# Product Change Notification

August, 2015

### **Bourns® Model FW, W, and WS Series Fixed Resistors**

### **Change to Packaging Dimensions/Tolerances of the Carrier Tape and Packaging Box**

#### Original Dimensions - FW Series

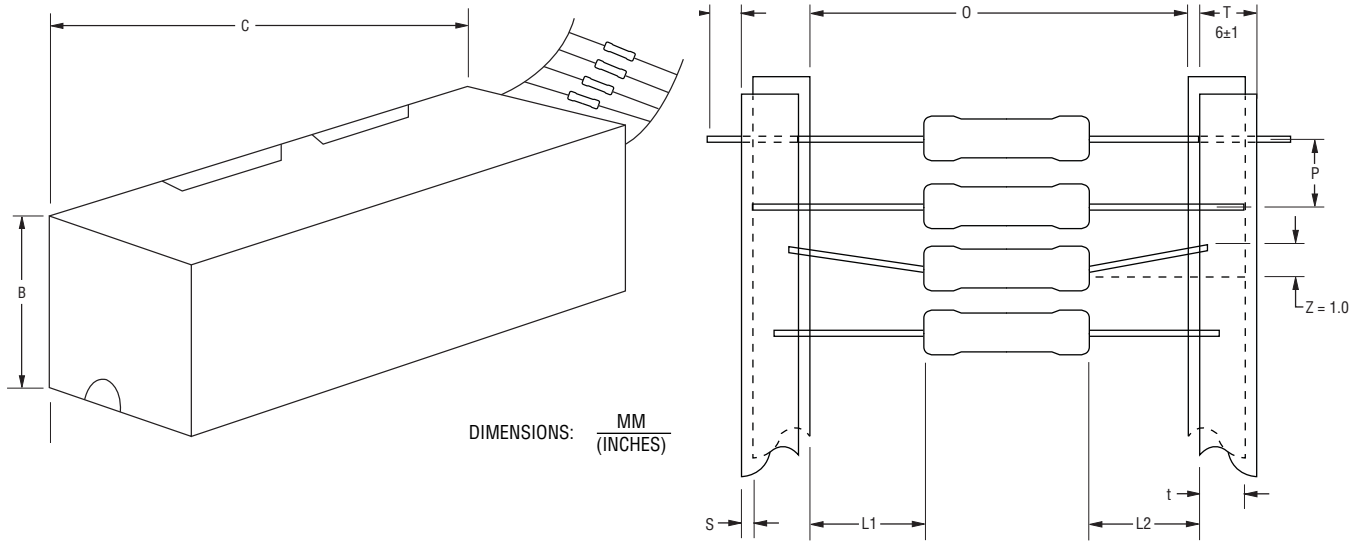
The Bourns® Model **FW**, **W**, and **WS** Series Fixed Resistors packaging dimensions/tolerances of the carrier tape and packaging box have changed. The specific dimensional changes and affected part numbers are listed on pages 2-5 of this notice.

Model	O	P	A	B	C	Qty./Box
FW10A (1 W)	$\frac{52 \pm 1}{(2.047 \pm .039)}$	$\frac{5 \pm 0.3}{(.197 \pm .112)}$	$\frac{75 \pm 5}{(2.953 \pm .197)}$	$\frac{70 \pm 5}{(2.756 \pm .197)}$	$\frac{255 \pm 5}{(10.039 \pm .197)}$	1,000 pcs.
FW20A (2 W)	$\frac{58 \pm 1}{(2.283 \pm .039)}$	$\frac{5 \pm 0.3}{(.197 \pm .112)}$	$\frac{80 \pm 5}{(3.150 \pm .197)}$	$\frac{82 \pm 5}{(3.228 \pm .197)}$	$\frac{255 \pm 5}{(10.039 \pm .197)}$	1,000 pcs.
FW30A (3 W)	$\frac{65 \pm 1}{(2.559 \pm .039)}$	$\frac{10 \pm 0.3}{(.393 \pm .112)}$	$\frac{90 \pm 5}{(3.543 \pm .197)}$	$\frac{119 \pm 5}{(4.685 \pm .197)}$	$\frac{255 \pm 5}{(10.039 \pm .197)}$	1,000 pcs.
FW50A (5 W)	$\frac{65 \pm 1}{(2.559 \pm .039)}$	$\frac{10 \pm 0.3}{(.393 \pm .112)}$	$\frac{90 \pm 5}{(3.543 \pm .197)}$	$\frac{88 \pm 5}{(3.465 \pm .197)}$	$\frac{255 \pm 5}{(10.039 \pm .197)}$	500 pcs.
FW70A (7 W)	$\frac{65 \pm 1}{(2.559 \pm .039)}$	$\frac{10 \pm 0.3}{(.393 \pm .112)}$	$\frac{90 \pm 5}{(3.543 \pm .197)}$	$\frac{88 \pm 5}{(3.465 \pm .197)}$	$\frac{255 \pm 5}{(10.039 \pm .197)}$	500 pcs.

Model	O	P	A	B	C	Qty./Box
FW10A (1 W)	$\frac{52 \pm 1}{(2.047 \pm .039)}$	$\frac{5 \pm 0.3}{(.197 \pm .012)}$	$\frac{75 \pm 5}{(2.953 \pm .197)}$	$\frac{70 \pm 5}{(2.756 \pm .197)}$	$\frac{255 \pm 5}{(10.039 \pm .197)}$	1,000 pcs.
FW20A (2 W)	$\frac{58 \pm 1}{(2.283 \pm .039)}$	$\frac{10 \pm 0.5}{(.394 \pm .020)}$	$\frac{90 \pm 5}{(3.543 \pm .197)}$	$\frac{119 \pm 5}{(4.685 \pm .197)}$	$\frac{255 \pm 5}{(10.039 \pm .197)}$	1,000 pcs.
FW30A (3 W)	$\frac{65 \pm 5}{(2.559 \pm .197)}$	$\frac{10 \pm 0.5}{(.394 \pm .020)}$	$\frac{90 \pm 5}{(3.543 \pm .197)}$	$\frac{119 \pm 5}{(4.685 \pm .197)}$	$\frac{255 \pm 5}{(10.039 \pm .197)}$	1,000 pcs.
FW50A (5 W)	$\frac{65 \pm 5}{(2.559 \pm .197)}$	$\frac{10 \pm 0.5}{(.394 \pm .020)}$	$\frac{90 \pm 5}{(3.543 \pm .197)}$	$\frac{88 \pm 5}{(3.465 \pm .197)}$	$\frac{255 \pm 5}{(10.039 \pm .197)}$	500 pcs.
FW70A (7 W)	$\frac{90 \pm 5}{(3.543 \pm .197)}$	$\frac{10 \pm 0.5}{(.394 \pm .020)}$	$\frac{90 \pm 5}{(3.543 \pm .197)}$	$\frac{124 \pm 5}{(4.882 \pm .197)}$	$\frac{500 \pm 5}{(19.685 \pm .197)}$	500 pcs.

#### Original Dimensions - W Series

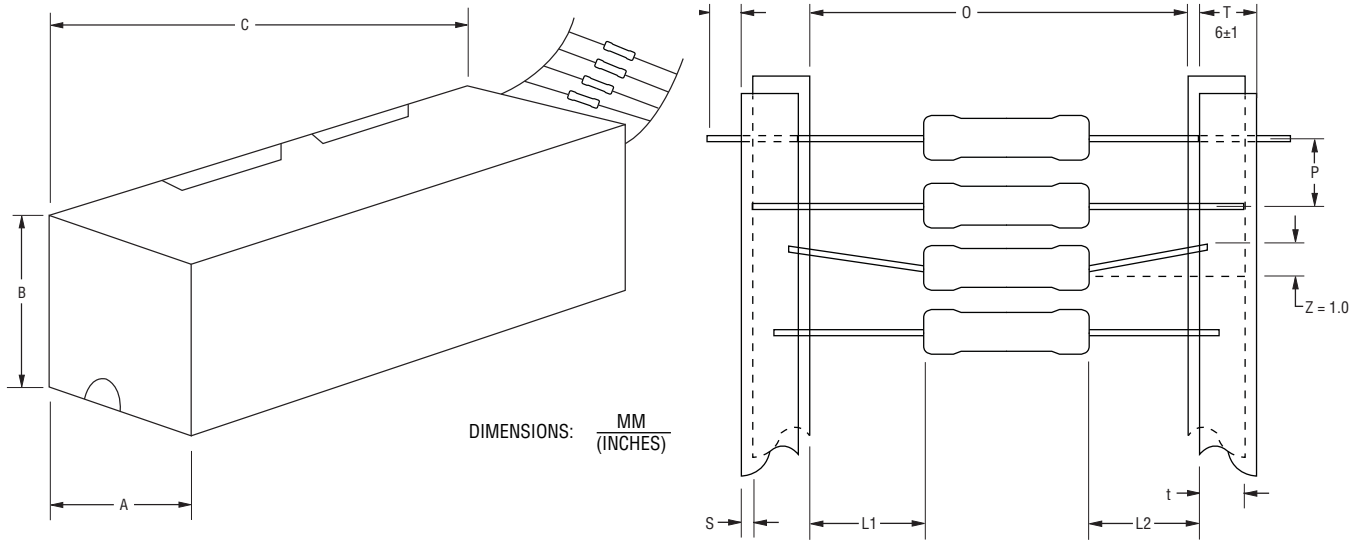
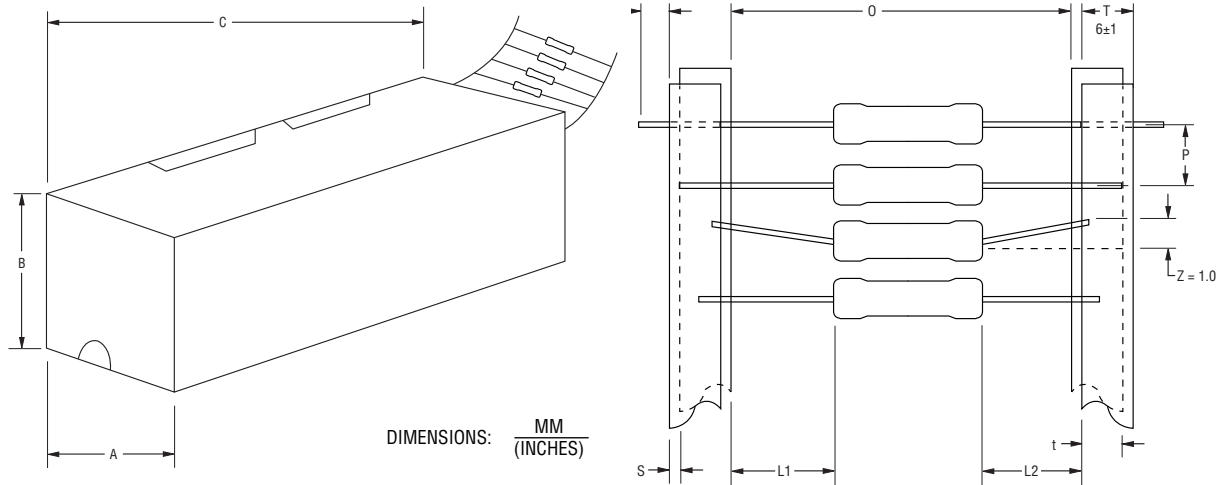
Model	O	P	A	B	C	Qty./Box
W1M	$\frac{58 \pm 1}{(2.283 \pm .039)}$	$\frac{5 \pm 0.3}{(.197 \pm .112)}$	$\frac{75 \pm 5}{(2.953 \pm .197)}$	$\frac{70 \pm 5}{(2.756 \pm .197)}$	$\frac{255 \pm 5}{(10.039 \pm .197)}$	1,000 pcs.
W2M	$\frac{58 \pm 1}{(2.283 \pm .039)}$	$\frac{5 \pm 0.3}{(.197 \pm .112)}$	$\frac{80 \pm 5}{(3.150 \pm .197)}$	$\frac{82 \pm 5}{(3.228 \pm .197)}$	$\frac{255 \pm 5}{(10.039 \pm .197)}$	1,000 pcs.
W3M	$\frac{65 \pm 5}{(2.559 \pm .197)}$	$\frac{10 \pm 0.3}{(.393 \pm .112)}$	$\frac{90 \pm 5}{(3.543 \pm .197)}$	$\frac{119 \pm 5}{(4.685 \pm .197)}$	$\frac{255 \pm 5}{(10.039 \pm .197)}$	1,000 pcs.
W5M	$\frac{65 \pm 5}{(2.559 \pm .197)}$	$\frac{10 \pm 0.3}{(.393 \pm .112)}$	$\frac{90 \pm 5}{(3.543 \pm .197)}$	$\frac{88 \pm 5}{(3.465 \pm .197)}$	$\frac{255 \pm 5}{(10.039 \pm .197)}$	500 pcs.
W7M	$\frac{90 \pm 5}{(3.543 \pm .197)}$	$\frac{10 \pm 0.3}{(.393 \pm .112)}$	$\frac{115 \pm 5}{(4.528 \pm .197)}$	$\frac{124 \pm 5}{(4.882 \pm .197)}$	$\frac{500 \pm 5}{(19.685 \pm .197)}$	500 pcs.

Model	O	P	A	B	C	Qty./Box
W1M	$\frac{58 \pm 1}{(2.283 \pm .039)}$	$\frac{5 \pm 0.3}{(.197 \pm .112)}$	$\frac{75 \pm 5}{(2.953 \pm .197)}$	$\frac{70 \pm 5}{(2.756 \pm .197)}$	$\frac{255 \pm 5}{(10.039 \pm .197)}$	1,000 pcs.
W2M	$\frac{58 \pm 1}{(2.283 \pm .039)}$	$\frac{10 \pm 0.5}{(.394 \pm .020)}$	$\frac{80 \pm 5}{(3.150 \pm .197)}$	$\frac{82 \pm 5}{(3.228 \pm .197)}$	$\frac{255 \pm 5}{(10.039 \pm .197)}$	1,000 pcs.
W3M	$\frac{65 \pm 5}{(2.559 \pm .197)}$	$\frac{10 \pm 0.5}{(.394 \pm .020)}$	$\frac{90 \pm 5}{(3.543 \pm .197)}$	$\frac{119 \pm 5}{(4.685 \pm .197)}$	$\frac{255 \pm 5}{(10.039 \pm .197)}$	1,000 pcs.
W5M	$\frac{65 \pm 5}{(2.559 \pm .197)}$	$\frac{10 \pm 0.5}{(.394 \pm .020)}$	$\frac{90 \pm 5}{(3.543 \pm .197)}$	$\frac{88 \pm 5}{(3.465 \pm .197)}$	$\frac{255 \pm 5}{(10.039 \pm .197)}$	500 pcs.
W7M	$\frac{90 \pm 5}{(3.543 \pm .197)}$	$\frac{10 \pm 0.5}{(.394 \pm .020)}$	$\frac{115 \pm 5}{(4.528 \pm .197)}$	$\frac{124 \pm 5}{(4.882 \pm .197)}$	$\frac{500 \pm 5}{(19.685 \pm .197)}$	500 pcs.
